Request for Revision of Monitoring Plan
"9 MW Neria Hydroelectric project, Karnataka, India"

CDM Registration No: 1549

Validation opinion as per requirement of EB49, Annex 28, para 7

The metering arrangement at the site is as follows:

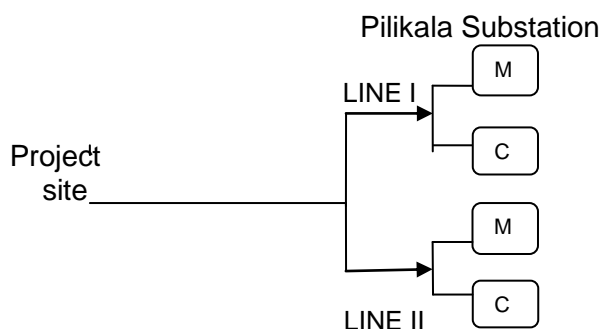
It was noticed during the site visit that the project was connected to the grid via two lines. The metering at Pilikala thus has four meters- a main and check meter at Line I and a main and check meter at Line II. The photographs taken at the site confirm the same. The registered PDD states that there are two meters, when actually there are two separate lines and four meters.

As was noticed during the site visit, the project was connected to the grid via two lines. The metering at Pilikala thus has four meters- a main and check meter at Line I and a main and check meter at Line II. The metering mentioned in the revised monitoring plan is correct. Photographs taken at the site confirm the same.
